# Product Safety Recall

## N192261860 Tonneau Cover Retention

**Revision:** 03

5504083

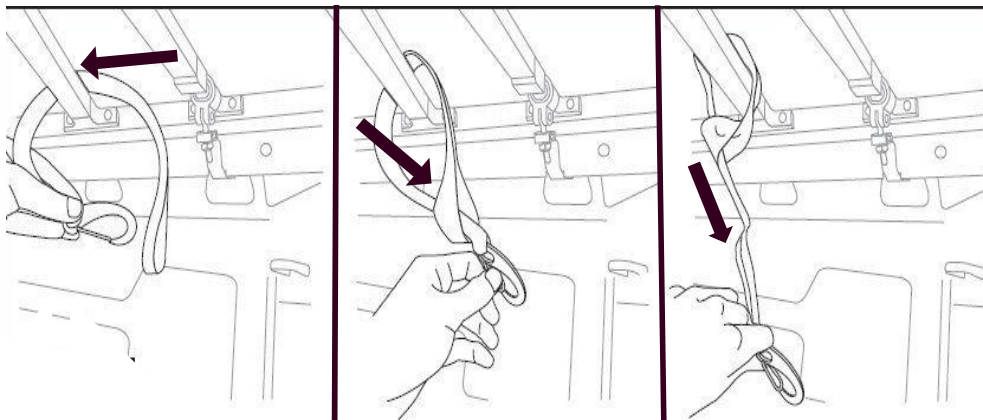
1. Open the vehicle tailgate and fold the two rear sections of the tonneau cover forward.

5504112

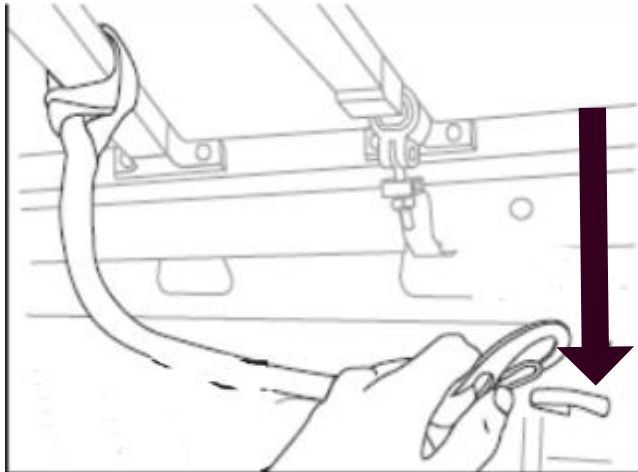
2. On the tonneau cover, locate the second crossbar from cab end of the pickup box. Loop the fabric strap over the outboard end.
3. Pull the metal buckle through the loop on the strap.

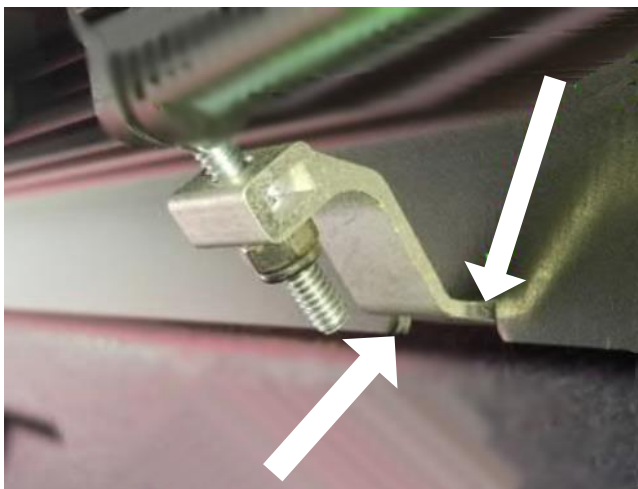
4. Clip the strap buckles to the upper **FRONT** cargo tie down loops.
5. Repeat steps 2-4 on the opposite side of the vehicle.
